Lee Hospital

REF: Control #10402
NRC License #37-05501-02

Enclosed is the additional information requested by Dr. Picone for continued processing of the requested amendment to our radioactive materials license.

NUCLEAR MEDICINE AIR FLOW DIAGRAM

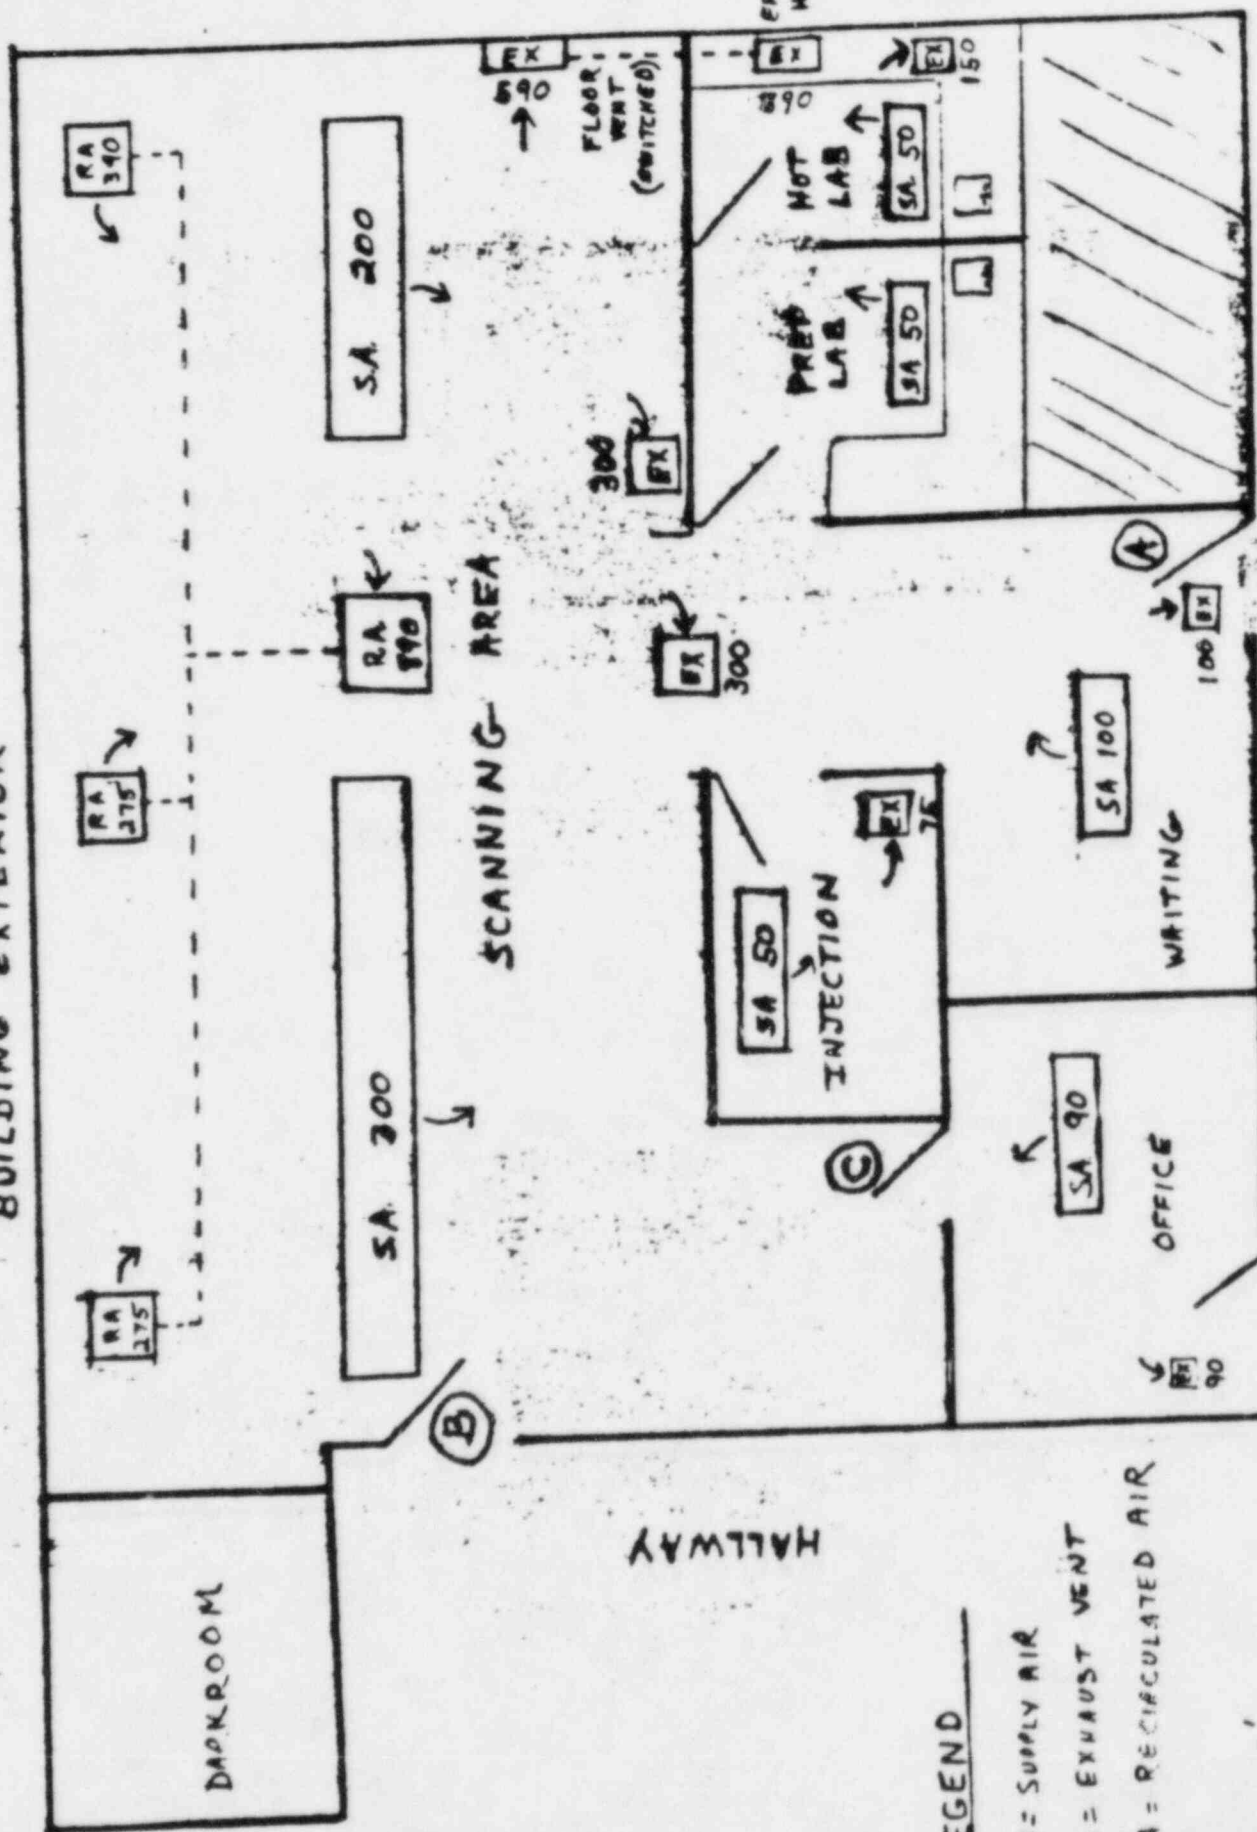
- a. The floor vent will be turned on (see note);
- b. Doors A, B and C will be closed (see diagram);
- c. A survey will be performed using a GM survey meter;
- d. Personnel will be evacuated, if necessary, until radiation levels return to normal.

- ① Confirm that manufacturer's instructions will be followed for Linerator
- ② For Xenon data submitted - supplement with
 - (A) provide emergency procedures
 - (B) describe use (when) of the floor vent
 - (C) where is the recirculated air re-circulated - in scanning room alone or hospital-wide

Note: The floor vent and the exhaust hood are switched on simultaneously via 3-way switches located in the scanning lab and the hot lab. The fan unit is located on the roof of the building. Access to this area is restricted to maintenance personnel via a locked doorway. Exhaust rates are checked semi-annually.

2. In reference to the Nuclear Medicine Air Flow Diagram, the recirculated air is a closed/sealed system used exclusively for the scanning area. The recirculation system utilizes a cooling unit to provide additional air conditioning during peak loads in the lab. Hence, the dotted line on the diagram showing the only connections. 04202
